UNITED STATES
NUCLEAR REGULATORY COMMISSION
WASHINGTON, D.C. 20555-0001

SUBJECT: CALVERT CLIFFS NUCLEAR POWER PLANT, UNITS 1 AND 2 – STAFF
ASSESSMENT OF RESPONSE TO 10 CFR 50.54(f) INFORMATION
REQUEST – FLOOD-CAUSING MECHANISM REEVALUATION
(TAC NOS. MF3097 AND MF3098)

STAFF ASSESSMENT BY THE OFFICE OF NUCLEAR REACTOR REGULATION
RELATED TO FLOODING HAZARD REEVALUATION REPORT
NEAR-TERM TASK FORCE RECOMMENDATION 2.1
RELATED TO THE FUKUSHIMA DAI-ICHI NUCLEAR POWER PLANT ACCIDENT
CALVERT CLIFFS NUCLEAR POWER PLANT, UNITS 1 AND 2
DOCKETS NO. 50-317 AND 50-318

Figure 3.2.-2 Schematic of HEC-HMS Model
(Source: CENG, 2013a, Figure 2.1-5)

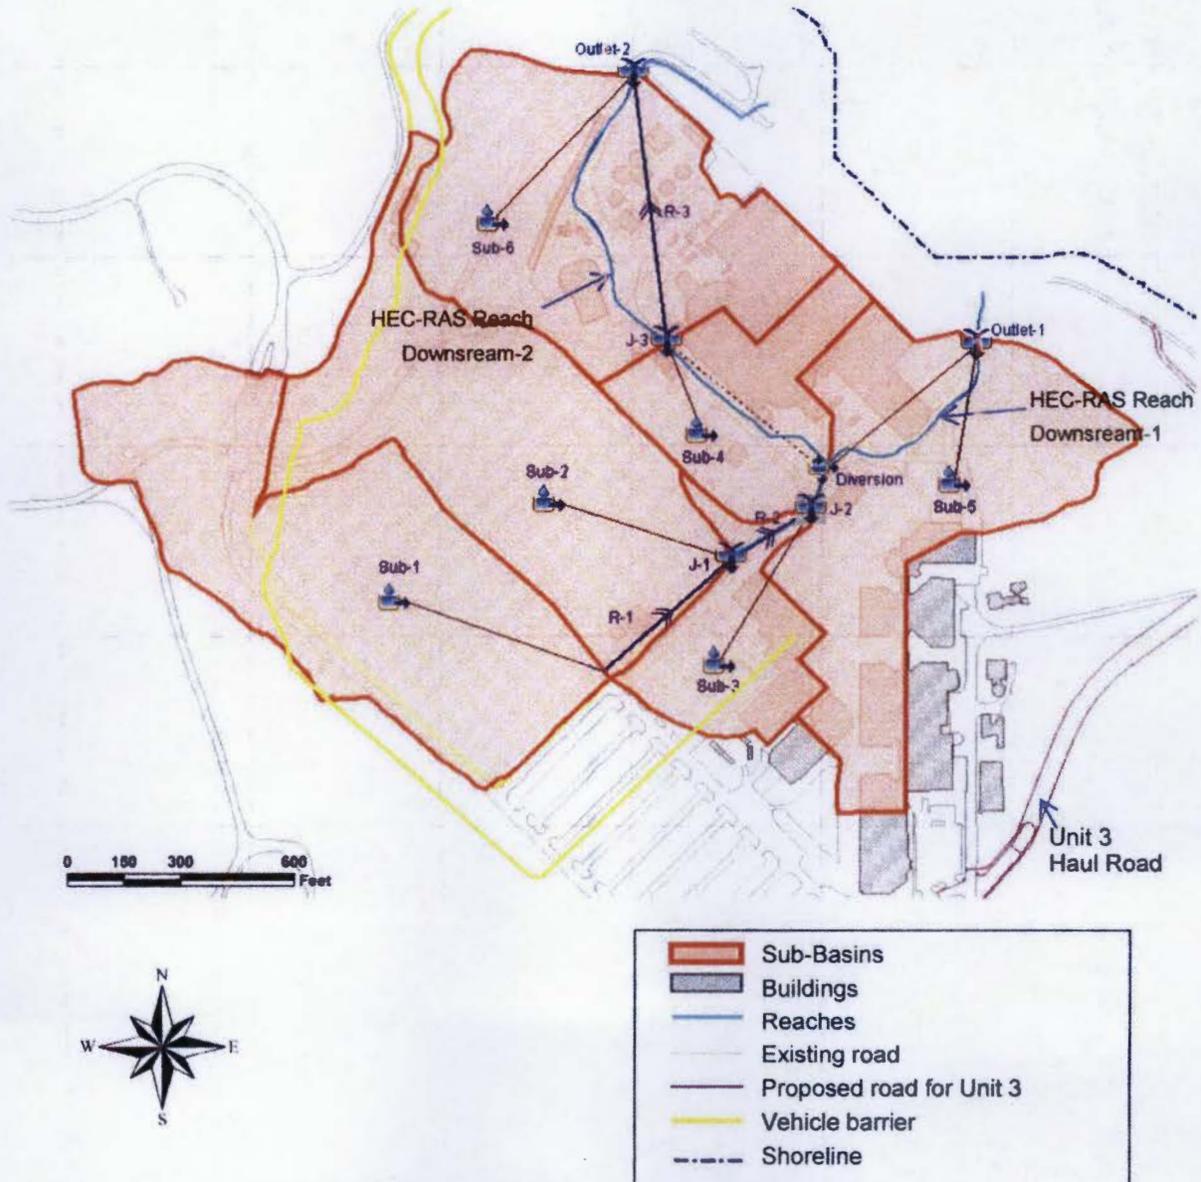
Reaches R-2 and R-3, which direct flow around the powerblock. Reaches R-1 and R-2 also are identified as Downstream 1 and 2 reaches, which flow to the southeast and southwest of the powerblock, respectively (see Figure 3.2-2). These downstream reaches discharge into the Chesapeake Bay at Outlet 1 and 2. Runoff from Subbasin 5 is routed through Outlet 1. Runoff from Subbasins 4 and 6 are routed through Outlet 2. Small storm drainage ditches and culverts are assumed to not function for the purposes of the PMF calculations.

The staff requested through an RAI, electronic versions of the HEC-HMS model input files used in the LIP analyses (NRC, 2014a). In its March 7, 2014, response, the licensee provided the requested files for staff's review (CENG, 2014c). After reviewing the information provided, the staff determines that the effect of uncertainty in the subbasin slope had not been sufficiently addressed by the licensee. The staff determines that this uncertainty could have a potentially significant impact on the PMP runoff lag time and the peak local intense precipitation flow rates. The staff further determines that the sheet flow characteristic length, blockage and conservatism of vehicle barriers, and roof drainage partitioning were not discussed. The staff conducted additional sensitivity analyses, and also reviewed the LIP characterization, as well as model boundary and initial conditions.

The staff conducted limited sensitivity analyses of these parameters, and also reviewed the LIP characterization, as well as model boundary and initial conditions. The staff altered the site parameters that were used to estimate the timing of the LIP runoff and evaluated that sensitivity of the model results. The staff determines that no significant change in the licensee's conclusion would be likely given reasonable additional conservatisms in parameter selections.

Figure 3.2-3 HEC-RAS Model Cross Section Plan
(Source: CENG, 2013a, Figure 2.1-7a)

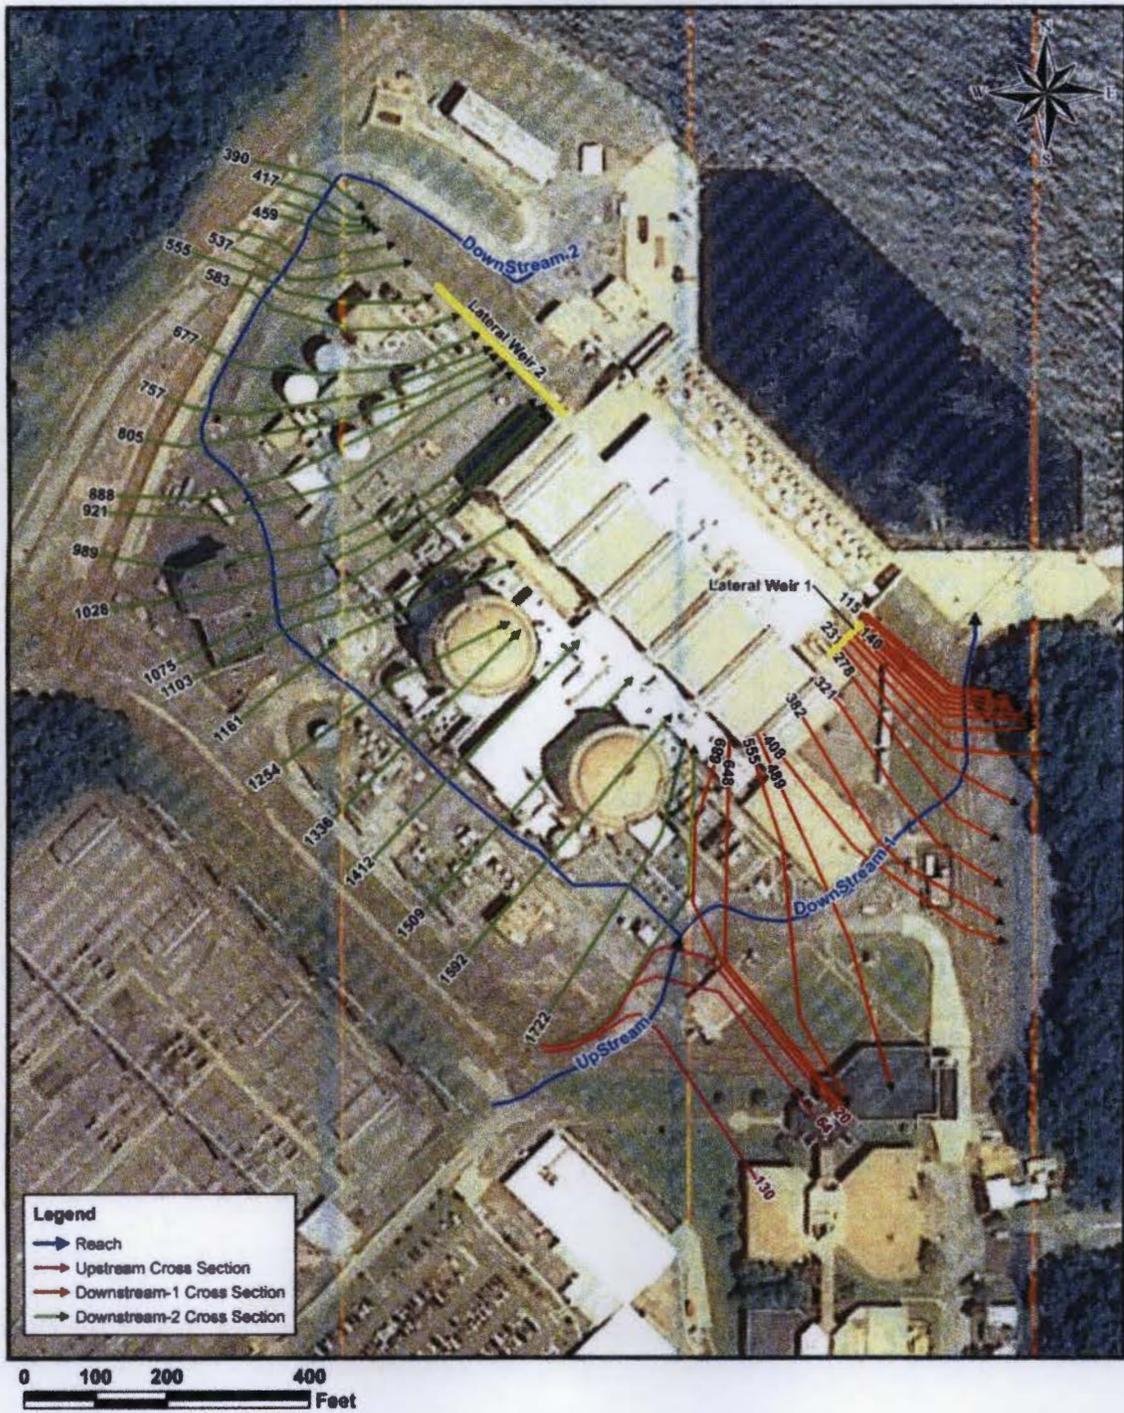
shown in Figure 3.1-1, and Figures 3.2-3 and 3.2-4 show the reach and cross section configuration.

In order to review the formulation of complex spatially and temporally distributed HEC-RAS model input, the staff requested through an RAI electronic versions of the HEC-RAS input files used for local intense precipitation analysis (NRC, 2014a). In its March 7, 2014 response, the licensee provided the requested input files (CENG, 2014c). Through an alternative HEC-RAS simulation, the staff determined that an alternative roof drainage could minimally increase the peak water-surface elevation resulting from the LIP event in the plant area above the licensee's base model. The staff specifically found that, if the turbine and reactor building drained precipitation off the west building edge rather than to the northwest, higher water-surface elevations would occur. The staff determined that while the alternative roof drainage could raise the peak water-surface elevations, the licensee's implementation of the LIP conceptual model was adequately represented by the HEC-RAS simulations.

The staff conducted a sensitivity analysis to evaluate the effect of elevation uncertainty on the estimated maximum water-surface elevations beyond the elevation uncertainty analysis described in Section 3.2.2. The staff altered channel cross section elevations in the HEC-RAS model including decreasing the elevations at the upstream ends of the flowpaths that occur along the west and south edges of the plant area, varying the elevation profile for each flow path was altered independently, and lowering the elevation of the upper cross section by 0.5 ft (0.2 m). The staff observed that the peak water-surface elevations were not significantly different than those found by the licensee.
